Re: Q-Station Interior Renovation
2808 Central Ave. SE Albuquerque, NM 87106
Traffic Circulation Layout
Engineer's Stamp 10-02-25 (K16-D204)

Based upon the information provided in your submittal received 10-07-25, the above referenced plan cannot be approved for Building Permit until the following comments are addressed:

Sheet TCL-A001

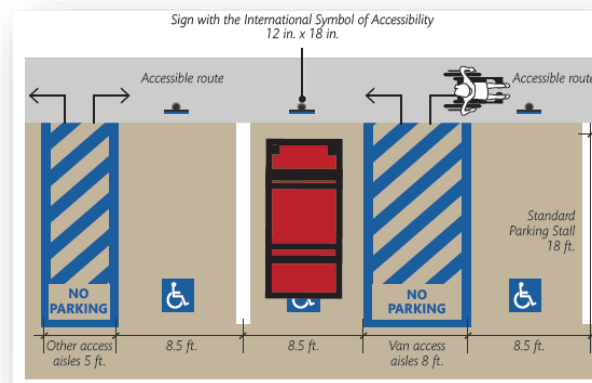
3. Show north arrow on plan sheet.
4. Provide an existing condition site plan sheet.
5. Show the median on Central Ave.
6. Show the existing driveway serving properties across the street on Vassar Dr.

7. If existing driveway on Vassar Dr. is to remain, it needs to be at a max 2% slope in all directions. If 2% in all directions is not met, provide a 4 foot ADA/pedestrian pathway meeting design standards. If intentions are to remove existing driveway, provide design details meeting current City and ADA standards.

8. Provide access alley width and identify all existing structures, i.e., utility poles.
9. When a site has four or more off-street parking spaces which require access off of an alley, the full width of the alley shall be paved from the parking access drive to a street, per the City Standards. The alleyway shall also be paved in the event that the dumpster for the proposed site is accessed off of the alleyway.

10. General Notes 'L' states about a relocation of the existing entrance alley way and parking utility poles. Please call out on existing site plan sheet structures proposed for removal and/or relocation.

11. Plan sheet calls out that both gates are to both be 24 feet. Gate at the alley appears to be shorter. Please verify.
12. All accessways to the site from the adjacent roadway shall be ADA-compliant.

FIGURE 7.4.115 Bicycle Parking Stall Layout Options

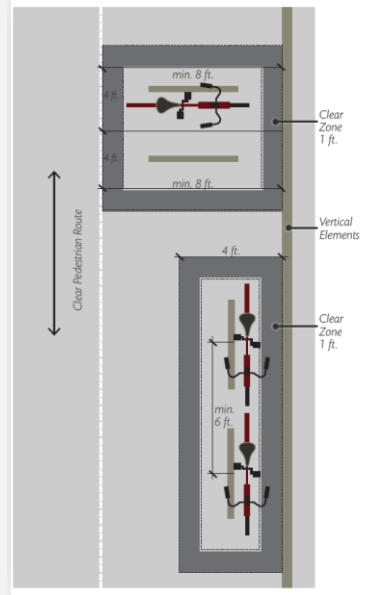
19. A 1-foot clear zone around the bicycle parking stall shall be provided.
20. Bicycle parking spaces shall be at least 6 feet long and 2 feet wide.
21. Site plan shows bicycle parking located within the 8 foot internal sidewalk. Bicycle rack detail drawing shows a 3 foot bicycle parking stall and 1 foot clear zone. Bicycle parking spaces must be at least 2 feet wide, equaling a 4 foot bicycle parking stall. Please verify and correct as needed.

22. Internal sidewalk shown has a width of 8 feet. The required 4 foot bicycle parking stall plus 1 foot perimeter clear zone will take up 6 feet of the sidewalk leaving 2 feet for pedestrian and ADA usage. Reevaluate and provided the minimum 4 feet clear pedestrian access route width free of obstruction and protruding objects.
